## Denver Zoning Code Text Amendment

### Cherry Creek East Commercial Mixed Use Design Overlay District (DO-9)

### Cherry Creek East Residential Design Overlay District (DO-10)

### LUTI MEETING DRAFT - 12/15/2022

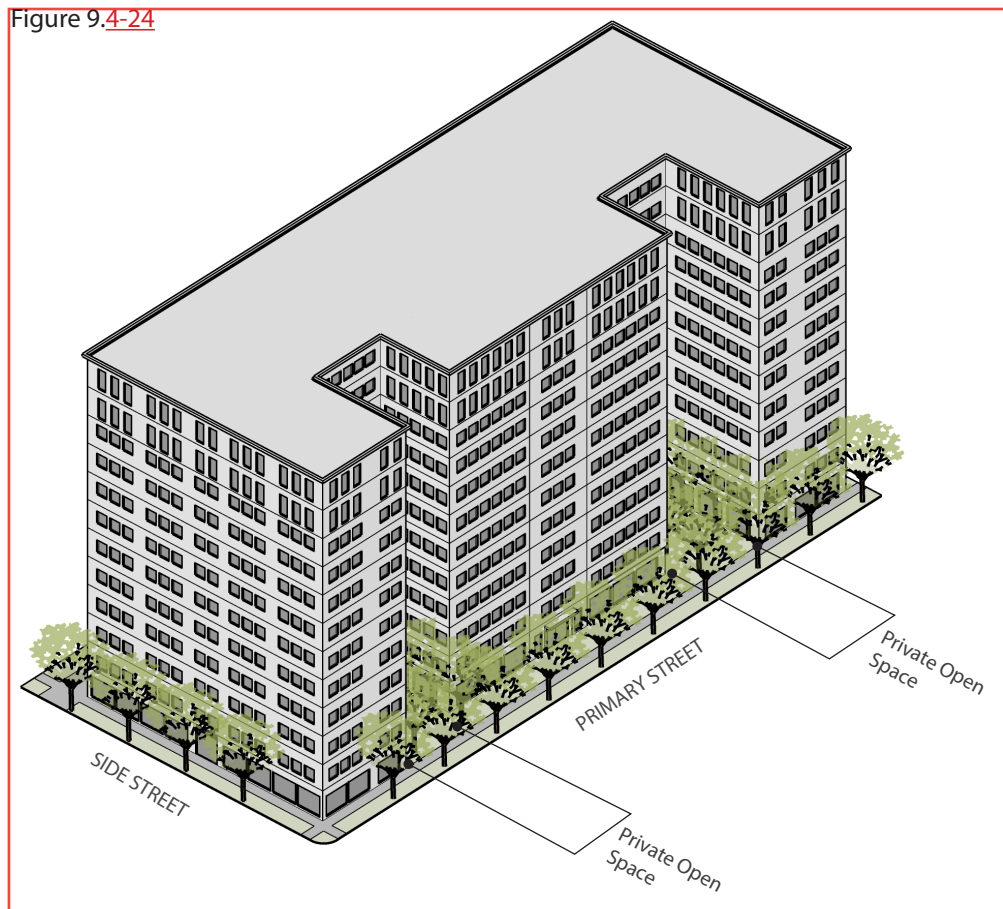
- i. Where a minimum 7 percent of the gross area of a Zone Lot is provided as Private Open Space meeting the rules of measurement set forth in Section 13.1.6.1.B, all Primary Structures on the Zone Lot shall not be required to meet the Street Level Primary and Side Street Setbacks. See Figure 9.4-24.

Figure 9.4-25

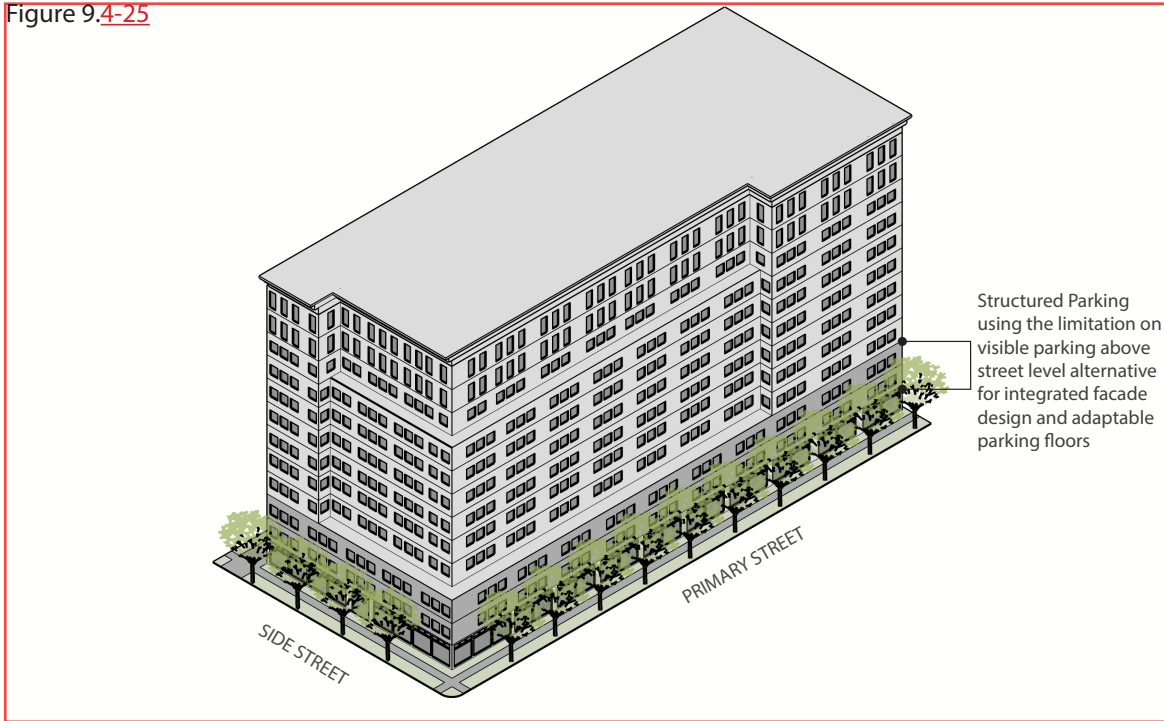
Where 100% of a street-facing building facade containing structured parking meets all the standards set forth in paragraphs i-iv below, the resulting integrated facade design and adaptable parking floors may be used as an alternative to the Limitation on Visible Parking Above Street Level in the DO-9 district. (See Figure 9.4-25)

i. Where the alternative is used, street-facing facades containing structured parking shall be integrated into the overall facade design through use of:

- a) Similar building materials to those used on adjacent facade areas that do not contain structured parking; and
- b) Facade articulation and fenestration patterns that integrate with portions of the building facade that do not contain structured parking.

ii. Where the alternative is used, street-facing facades containing structured parking shall minimize the visibility of parking areas through use of:

- a) Non-transparent facade materials for a minimum height of 4 feet from the finished floor of each story; and
- b) Fully-shielded LED or other lighting not exceeding 6,500 lumens behind a street-facing facade.

iii. Where the alternative is used, street-facing facades containing structured parking shall be designed with parking floors that are adaptable to other uses for a minimum depth of 30 feet from the Primary or Side Street-facing building facade through use of:

- a) A minimum 12-foot floor-to-floor height, measured from the upper surface of the floor to the upper surface of the floor or roof next above; and
- b) Floor plates that are level except to the minimum extent required for proper drainage; and
- c) Structures that are constructed to accommodate loads associated with office buildings per the International Building Code.

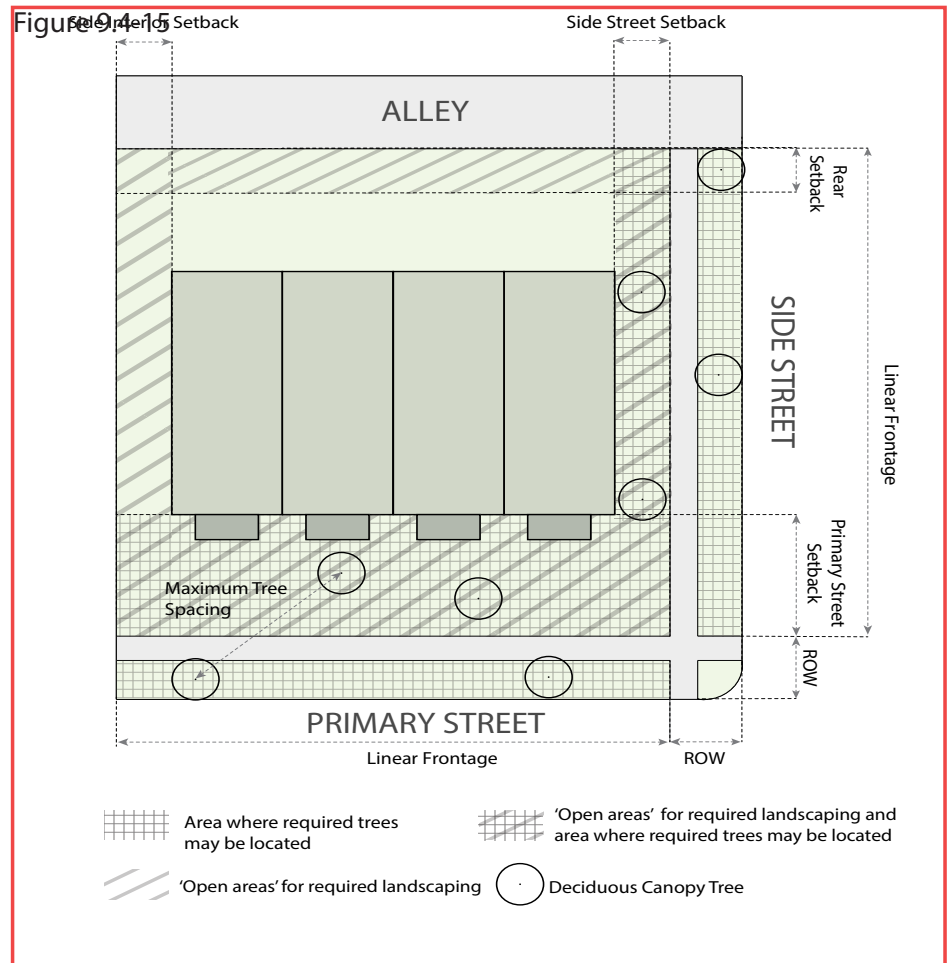
i. A minimum of 60% of the applicable "open areas" shall be landscaped with live planting material and the remaining 40% shall be landscaped with either live or non-live landscaping material, according to Section 10.5.4.6 Landscaping Material Standards. See Figure 9.4-15.

iii. On each Zone Lot, 1 deciduous canopy tree shall be planted for every 25' of linear frontage. Spacing of trees may vary, but the maximum spacing is 40'. See Figure 9.4-15.
